SUBJECT: COMANCHE PEAK NUCLEAR POWER PLANT, UNITS 3 AND 4
DOCKET NUMBERS 52-034 AND 52-035
SUPPLEMENTAL INFORMATION FOR RESPONSE TO REQUEST FOR ADDITIONAL
INFORMATION NO. 4725 (SECTION 2.5.2) AND 4841 (SECTION 2.5.4)

Supplemental Response to Request for Additional Information No. 4725 (CP RAI #168)

RAI NO.: 4725 (CP RAI #168)

Figure 1 – Rondout contributing sources and the extended earthquake catalog

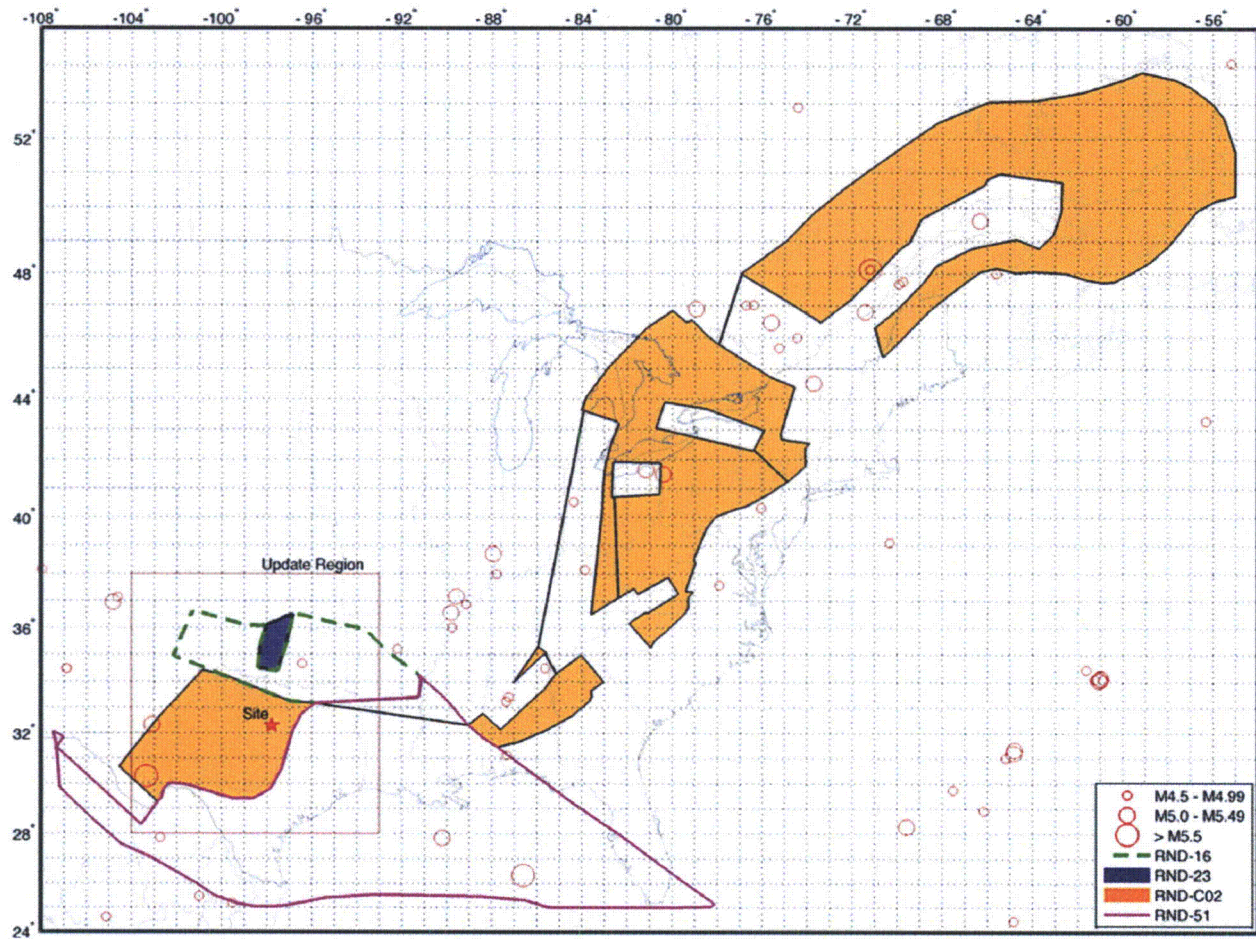
In response to RAI 2.5.2-1 (ML093080116), you provided an updated supplementary earthquake catalog which extended the spatial coverage of the initial Comanche Peak Nuclear Power Plant (CPNPP) earthquake catalog to enclose all seismic sources used in the CPNPP hazard study. In your response, you stated that based on the supplementary earthquake catalog there are two seismic sources whose maximum earthquake magnitude (Mmax) values need to be updated and you did not discuss updates to the probability of activity (Pa) values based on the occurrence of earthquakes. In accordance with NUREG-0800, Standard Review Plan, Chapter 2.5.2, "Vibratory Ground Motion," and Regulatory Guide (RG) 1.208, "A Performance-Based Approach to Define the Site-Specific Earthquake Ground Motion", please explain the following:

- b. The supplementary earthquake catalog includes a moderate-sized earthquake that occurred on 08/10/2005 with a magnitude of 5.4 within a few of the seismic sources used for the CPNPP hazard study. Although you evaluated the impacts of this earthquake on Mmax model parameters and conducted a sensitivity study to assess its impacts as part of your RAI response, your response did not address the issue of Pa values of these sources. The Law Engineering Earth Science Team's (EST's) seismic source zone 26, for which you updated the Mmax value, has a Pa value of 0.6. Since there is now already a large earthquake in this source, its Pa value requires updating. Similarly, this earthquake also falls within the Bechtel EST's zone 39 with a Pa value of 0.2 and the Woodward Clyde EST's zone 46a with a Pa value of 0.08. Please provide an update to your RAI 2.5.2-1 response considering the impacts of Pa updates.

- c. Please also provide an assessment of the impacts of the updated Mmax and Pa values on the EPRI-Seismicity Owners (SOG) seismic sources that were not used in the original calculations because their initial hazard contributions were less than 1% of the total hazard, such as the Gulf coast sources and the

- Rondout zone C02 (Grenville Crust)
 - The 11 November 1988 Mw 5.9 Saguenay earthquake in Quebec (Figure 1); and
 - The September 25, 1998 mb 5.2 Pymatuning earthquake in western Pennsylvania (Figure 1).

The potential impact of the earthquakes is discussed in the paragraph below. This paragraph supersedes the corresponding paragraph in the response to Question 02.05.02-1.

Contributing EPRI-SOG source zones for the Rondout team with earthquakes from the supplemental catalog (red circles). Region of updated catalog is shown as a red box. The Mw 5.9 Saguenay earthquake is located in southern Quebec at -71.2° E and 48.1° N in the northernmost polygon of zone C02. The mb 5.2 Pymatuning earthquake is located in western Pennsylvania at -80.4° E and 41.5° N in the second northernmost polygon of zone C02.
